# Groundwater Monitoring Plan

## Corrective Action Management Unit (CAMU) Area

December 16, 2008

**Appendix A**  
**Responses to Nevada Division of Environmental Protection Comments dated**  
**November 13, 2008, regarding Groundwater Monitoring Plan (October 28, 2008)**  
**Corrective Action Management Unit (CAMU) Area**  
**NDEP Facility ID# H-000688**

FIGURE 3

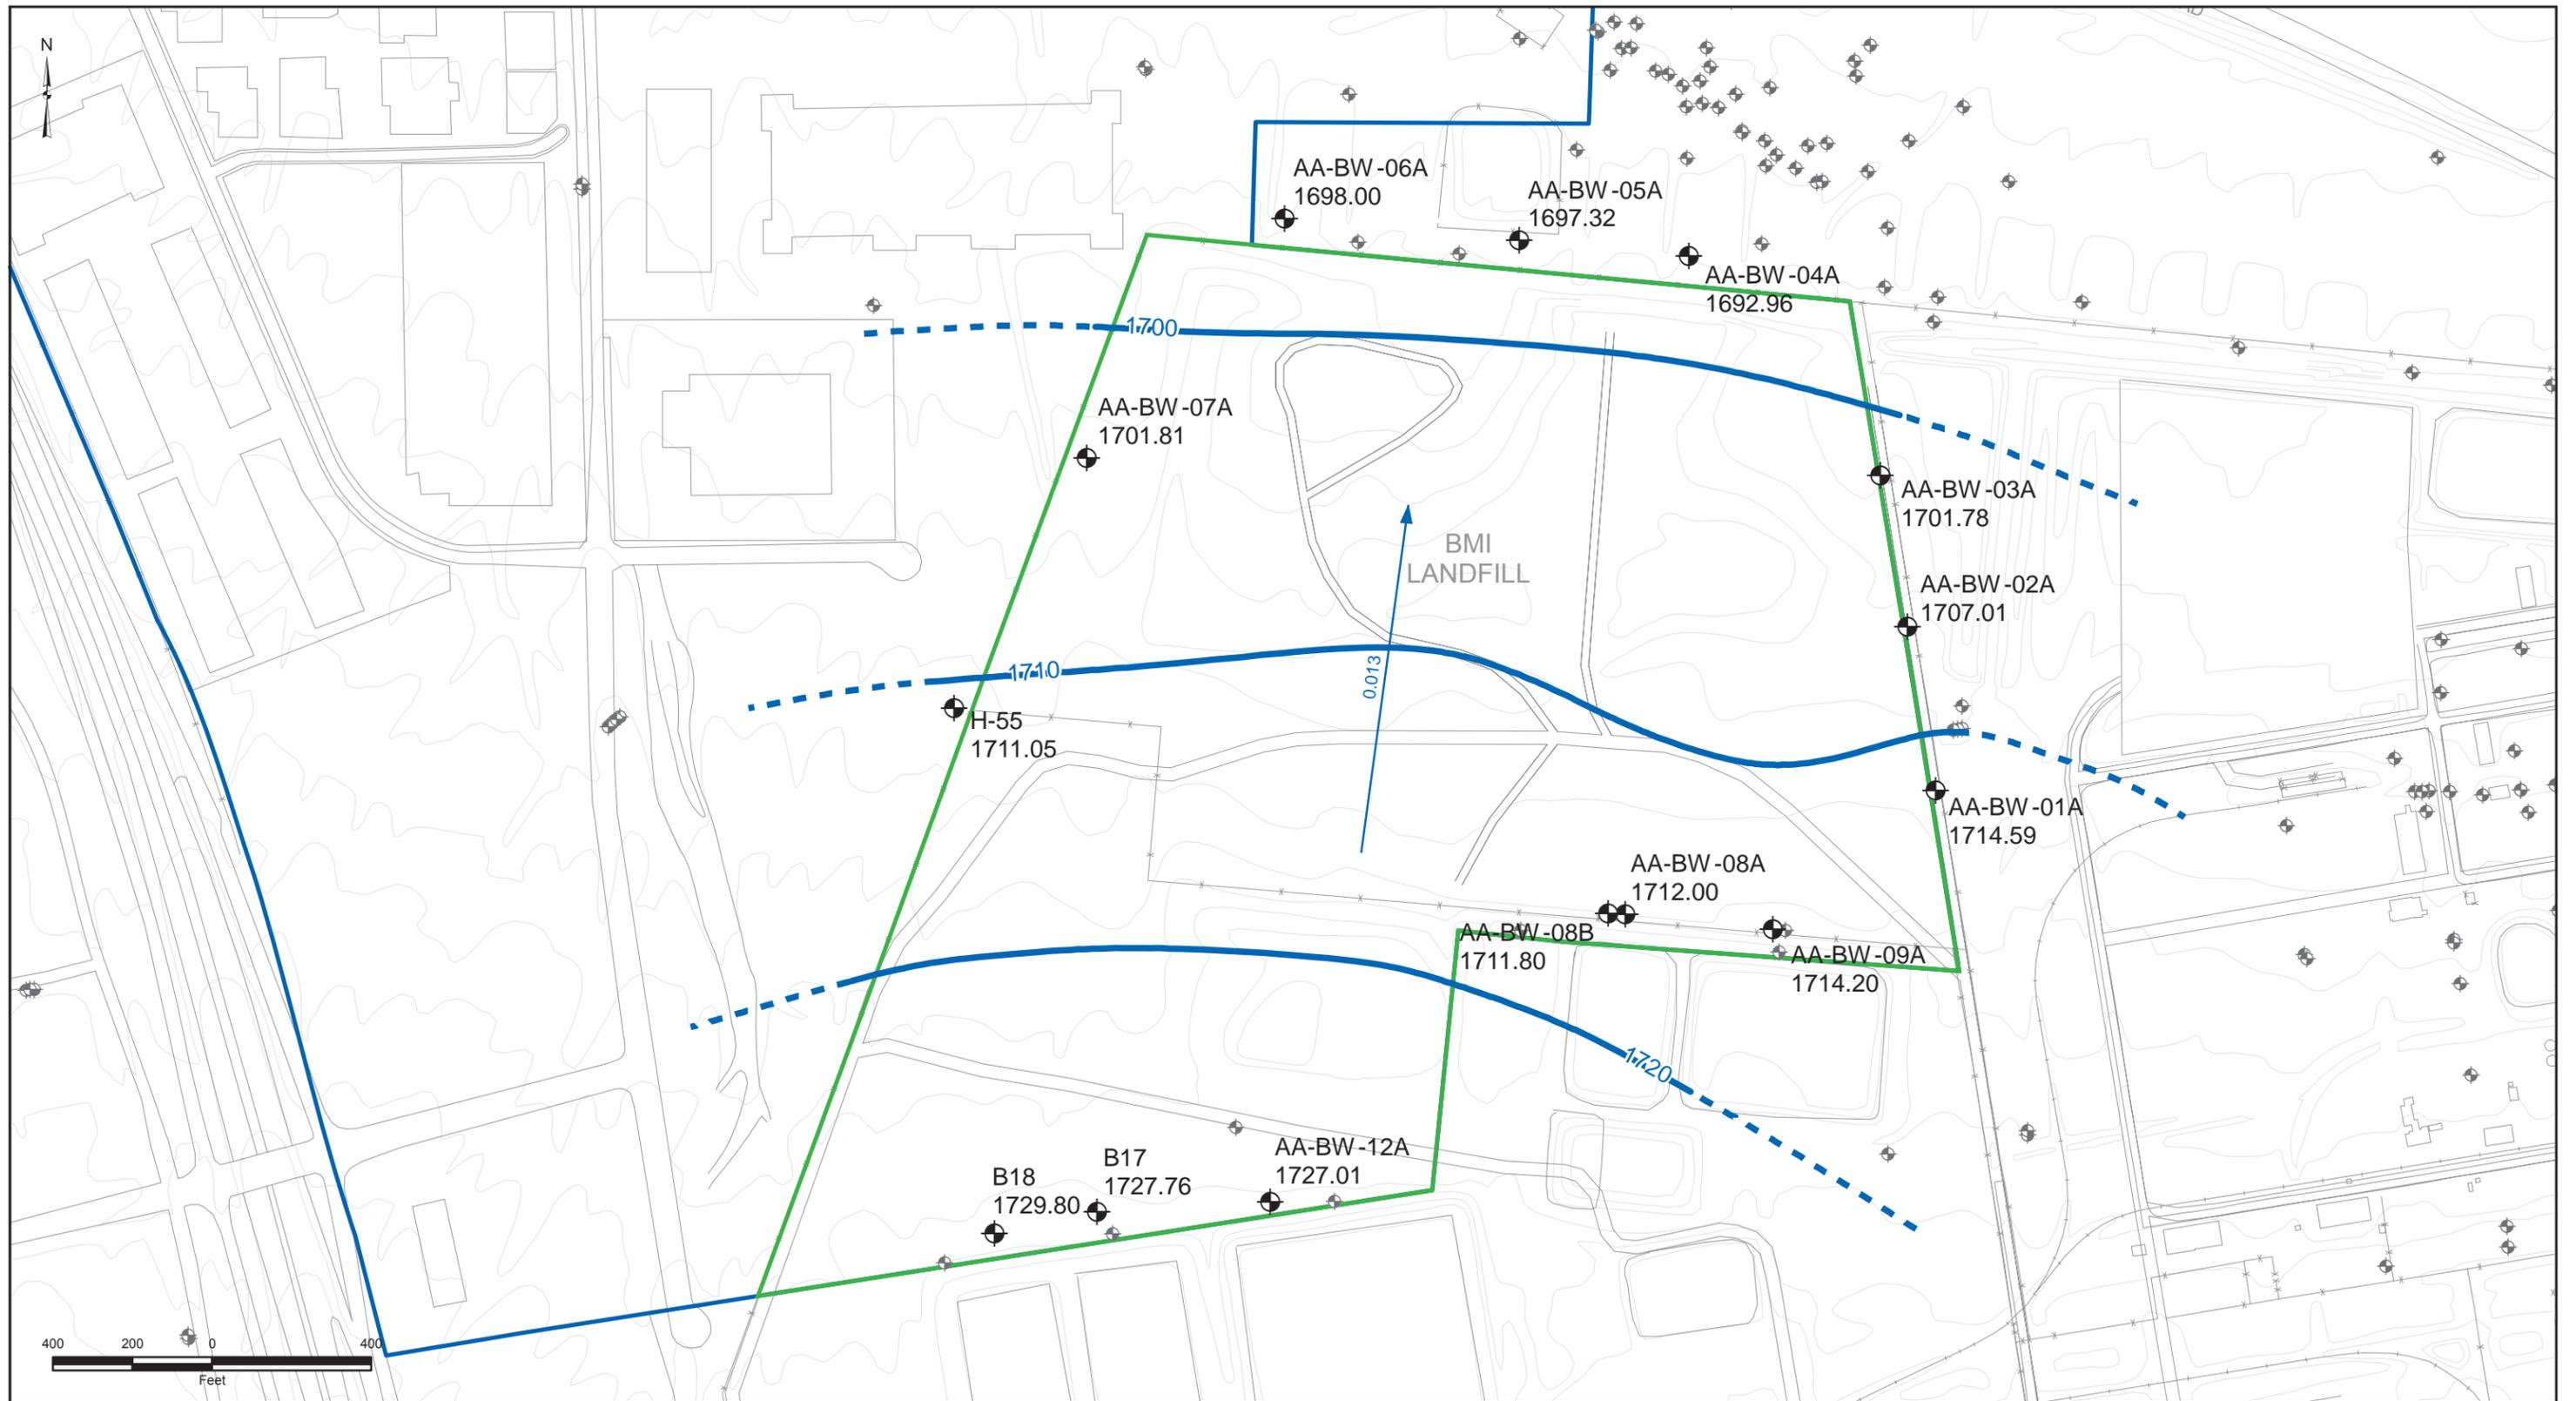
9. Section 1.3.3, pg 8, 1<sup>st</sup> paragraph of the section. BRC states “Although preferred groundwater flow and SRC transport may be inferred by the higher Kh data, the Aa groundwater flow map for the area (Figure 3) does not indicate that higher-Kh paleochannels affect groundwater flow near the CAMU.” It is noted that there are an insufficient number of groundwater elevation control points to support this statement.

**Response:** Comment noted

**FIGURE 4  
CAMU AREA  
MONITORING WELLS**

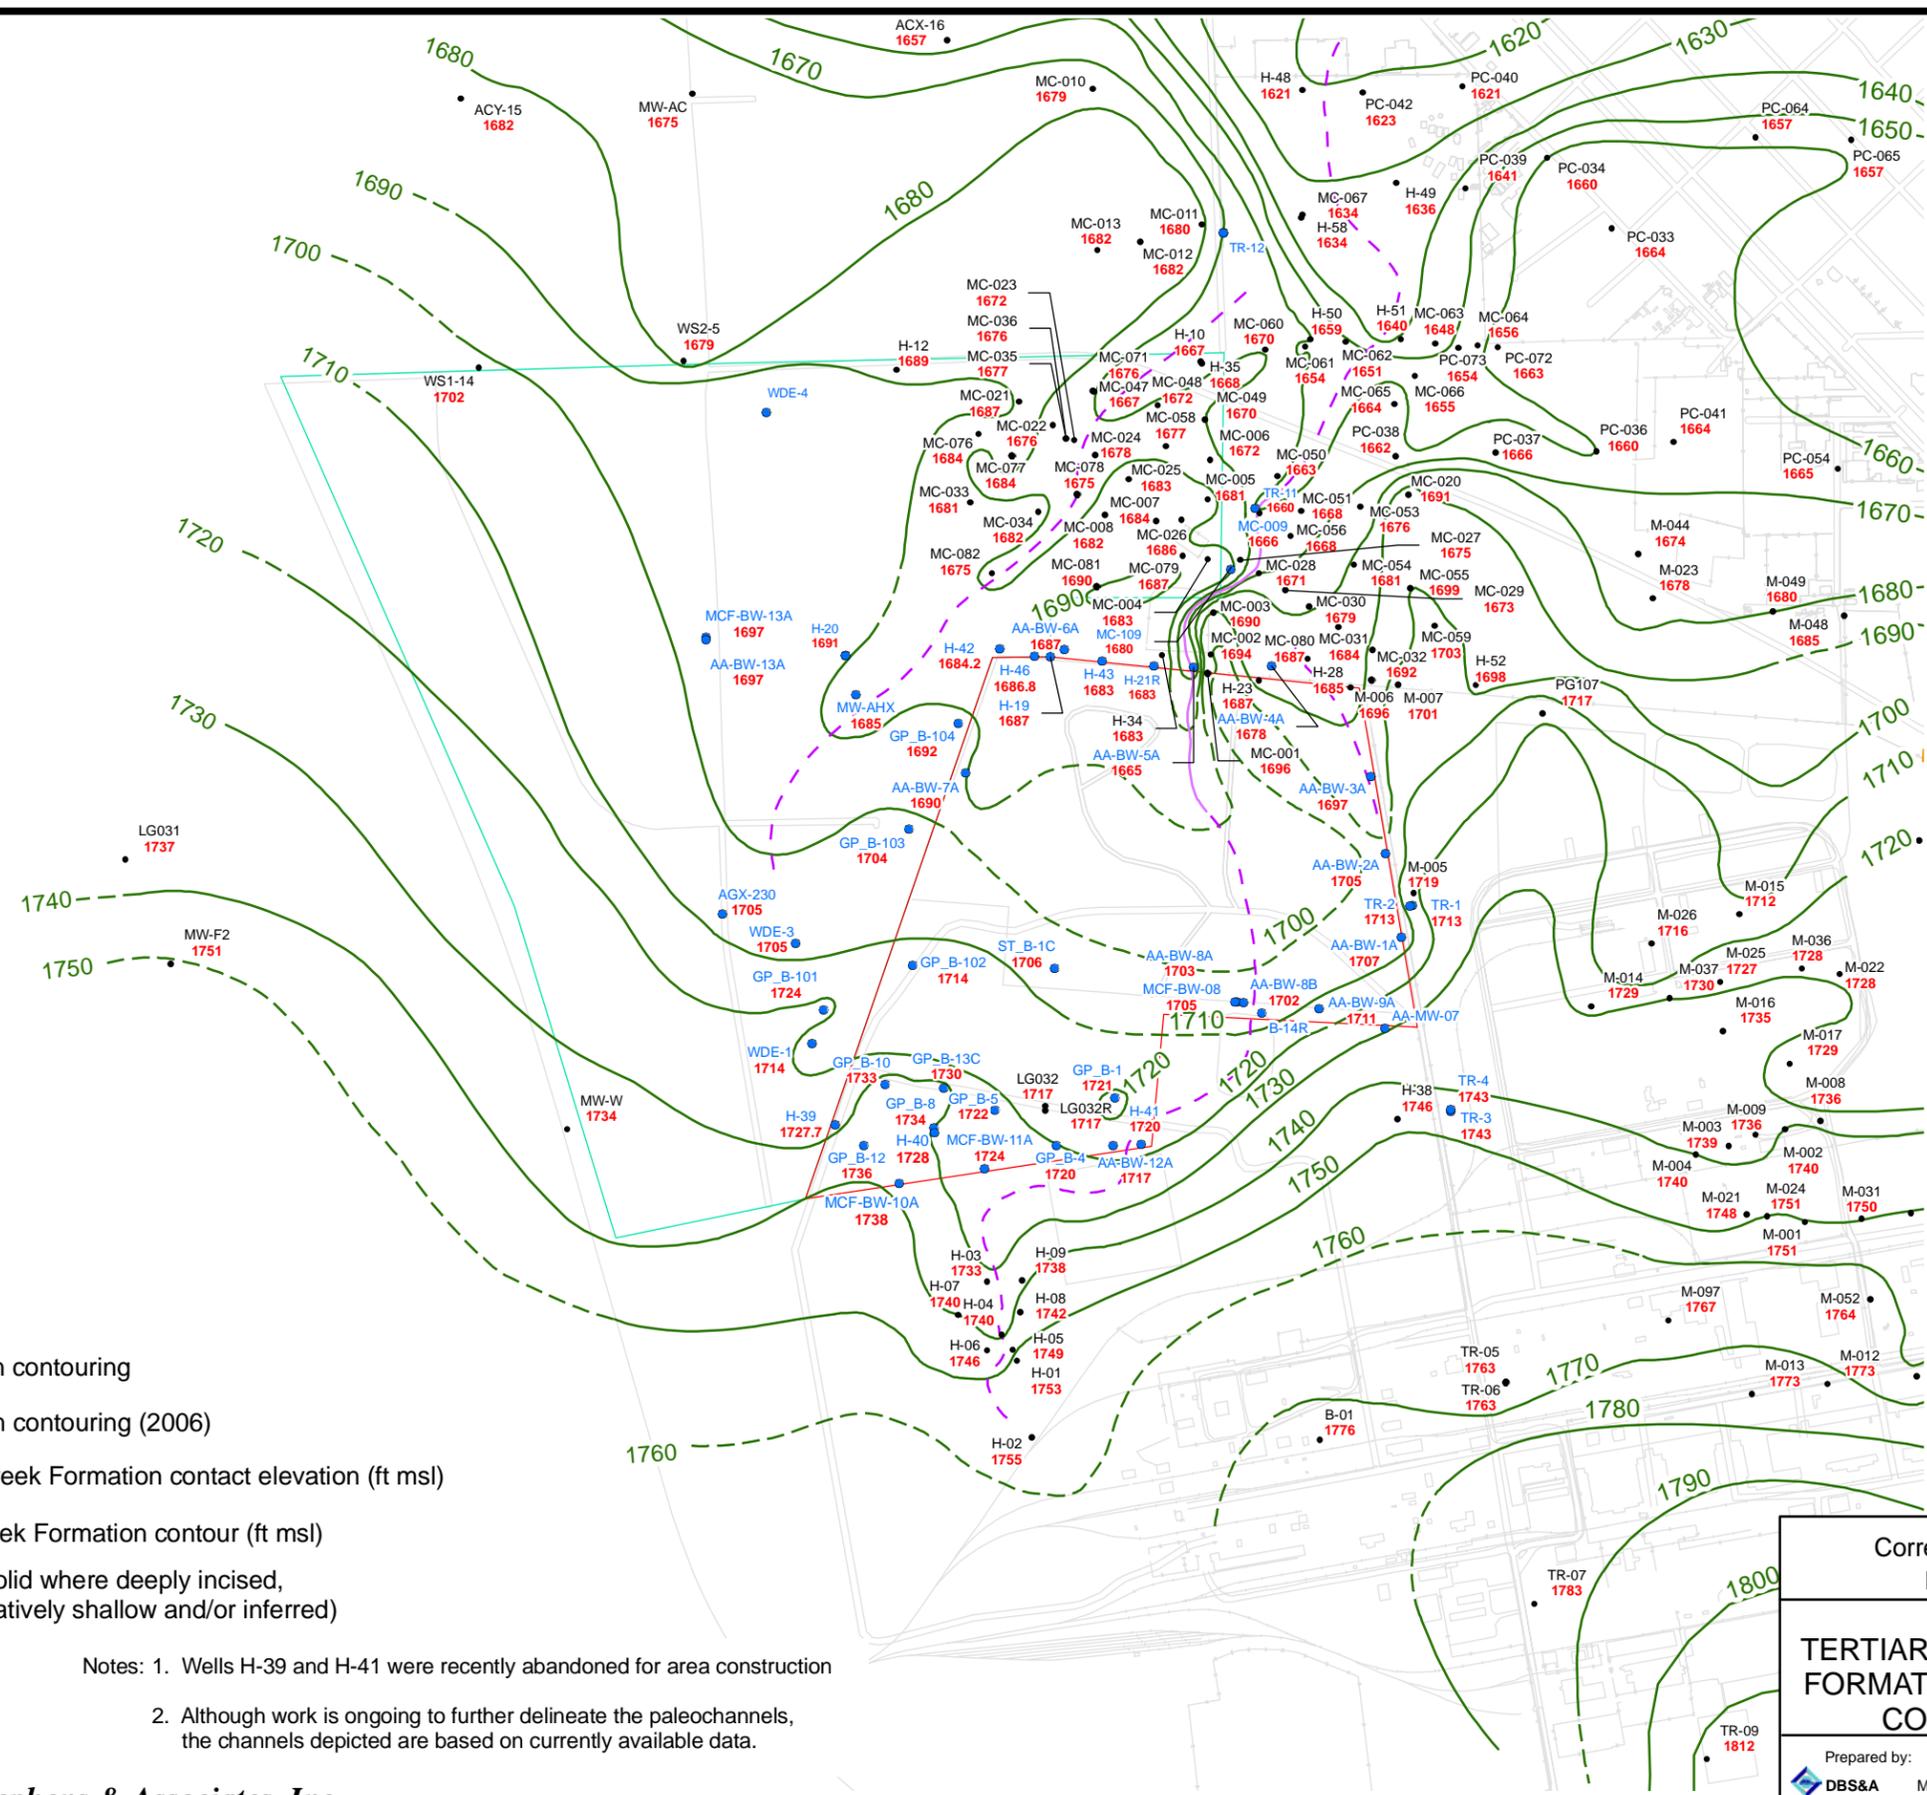
16. Figure 4, this figure is still incomplete as wells are missing.

**Response:** Figure 4 in the October 28, 2008 version of the plan included only Shallow Zone wells. Middle Zone and Deep Zone wells were not included on this map.

**FIGURE 7  
PROPOSED CAMU AREA  
MONITORING PROGRAM**

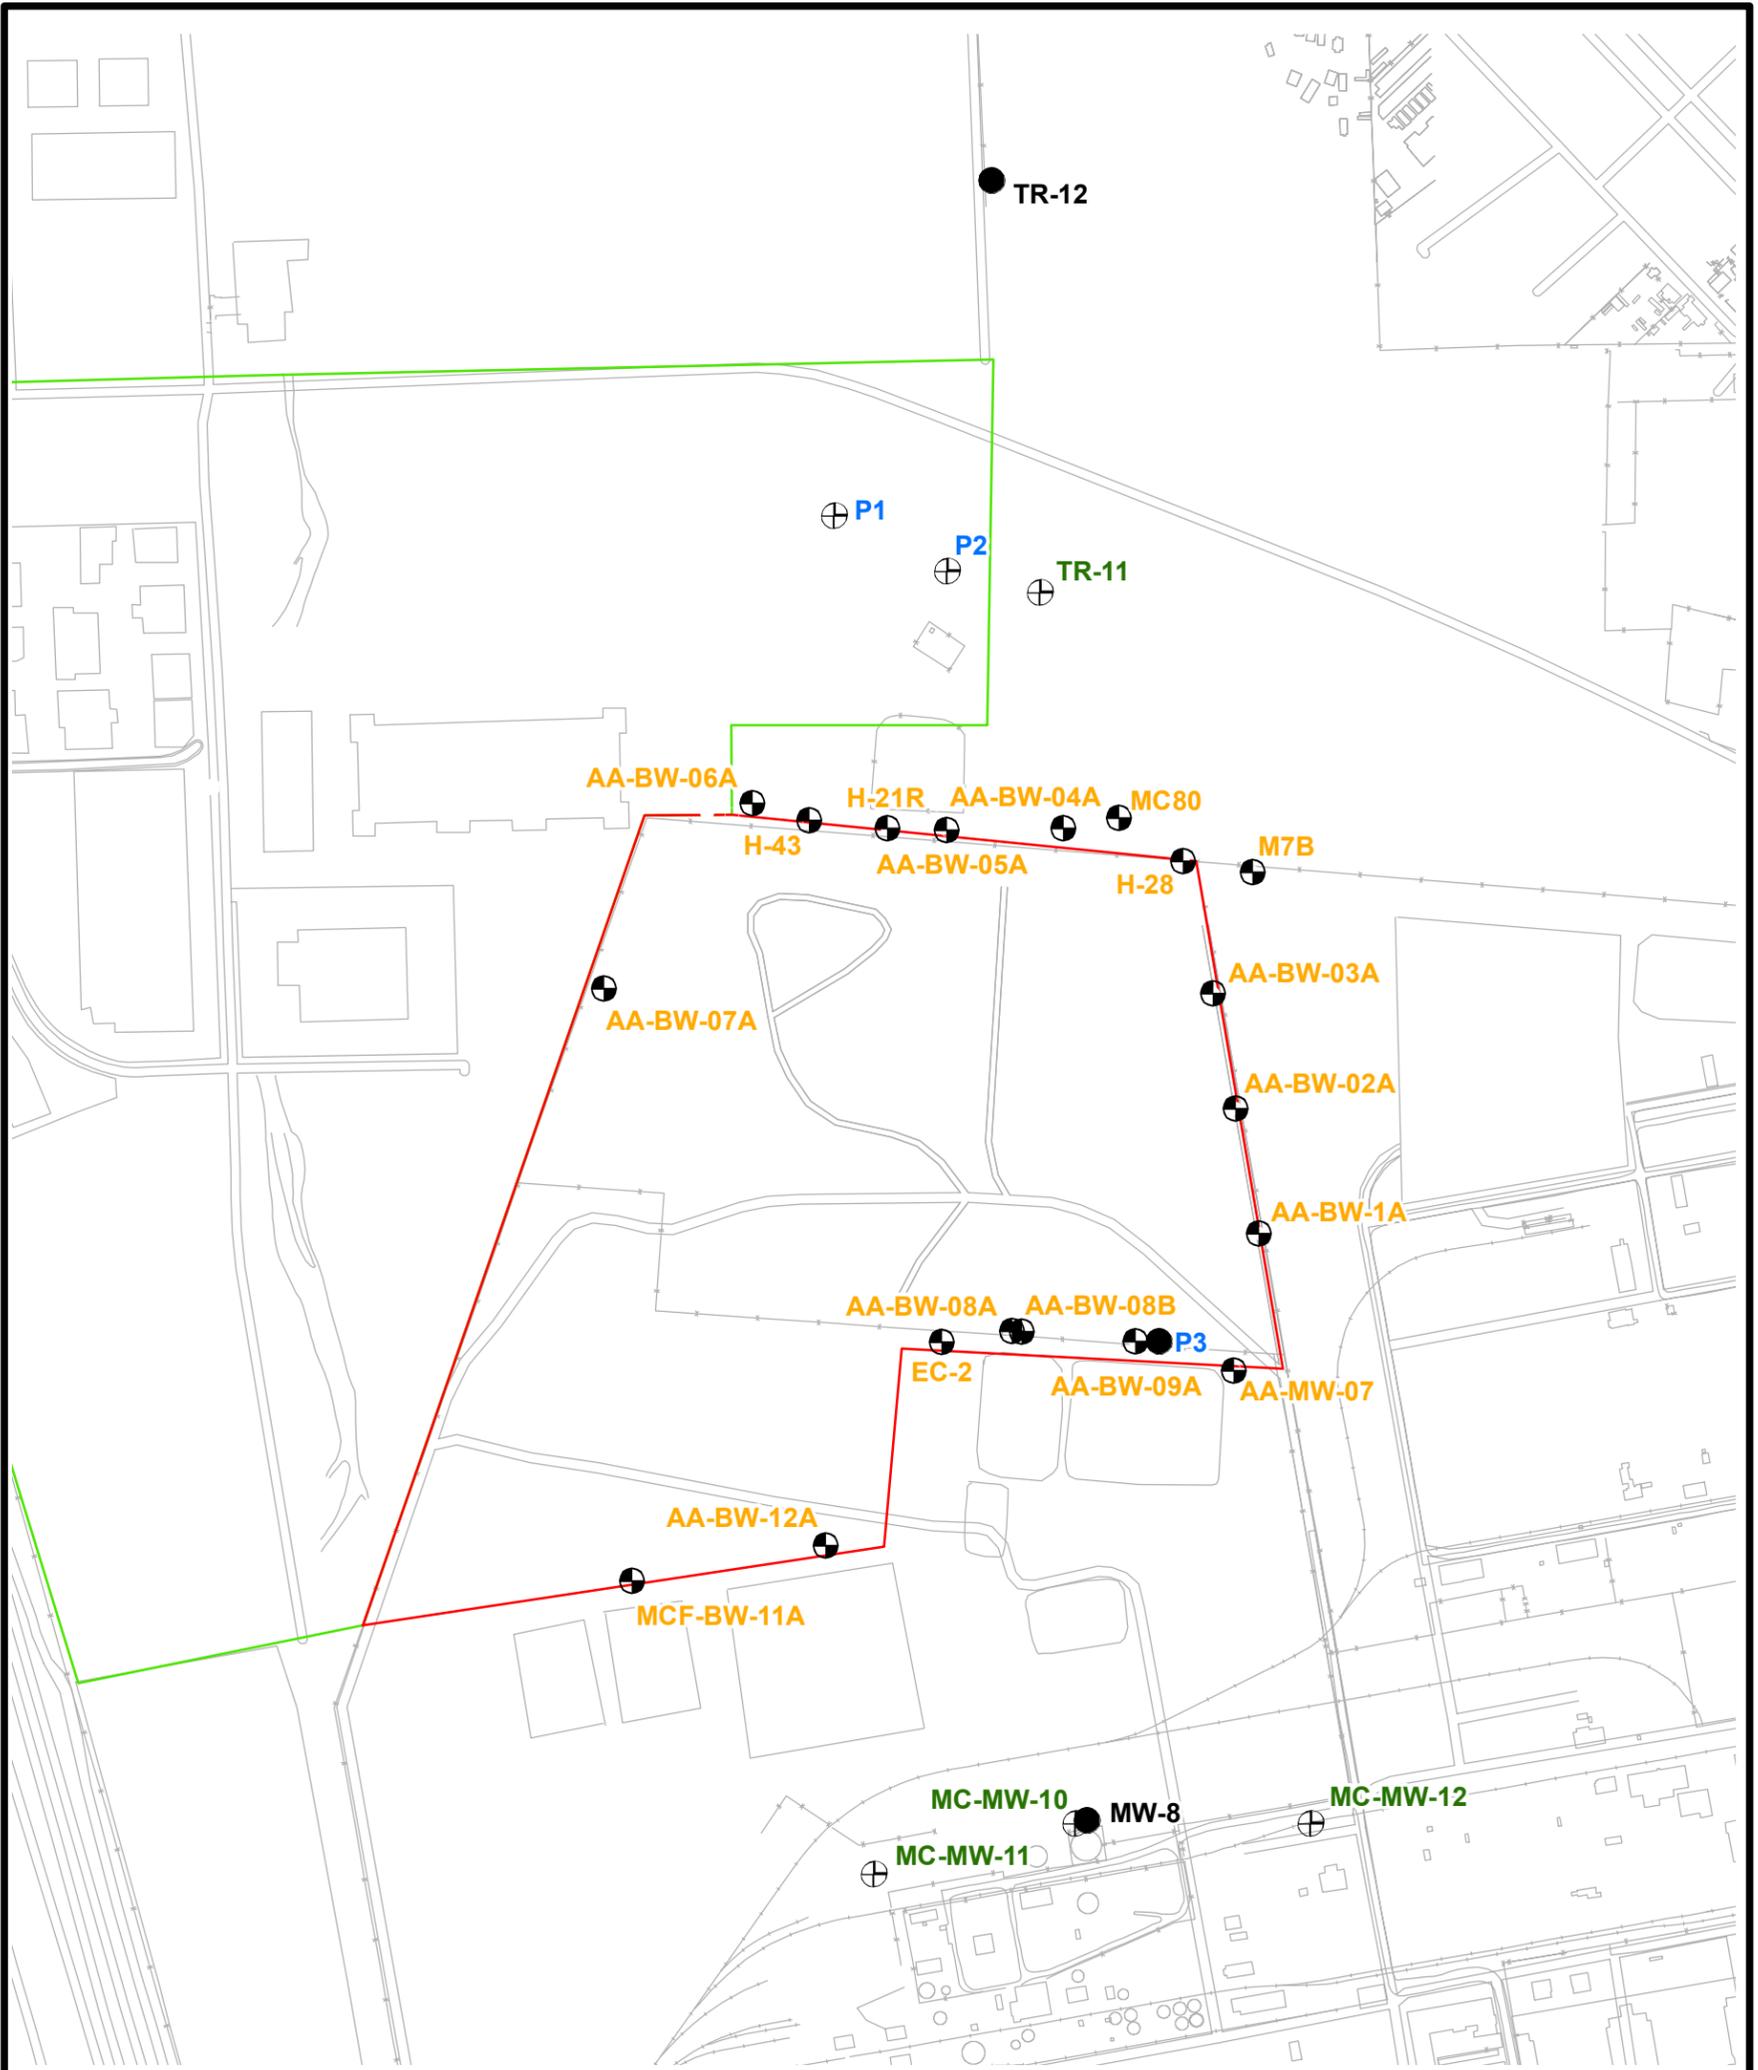
17. Figure 7, the NDEP has the following comments:

- a. *Please investigate the viability of including well M-5A on the east side of the CAMU area and add this well to the program, if applicable.*

21. NDEP Comment 3 (b), BRC Response. *There are no wells in the southwest corner of the site, see Figure 7.*

**Response:** BRC investigated the applicability of including this well. Because Shallow Zone well M-5A is located near and between two Shallow Zone wells already included in the plan (AA-BW-01A and AA-BW-02A), this area is considered to be sufficiently covered in the plan and M-5A is not needed.

**Response:** Well AA-BW-07A and MCF-BW-11A are now included in the plan to evaluate groundwater conditions in the western and southwestern portions of the CAMU area (also see response to Comment 17b).
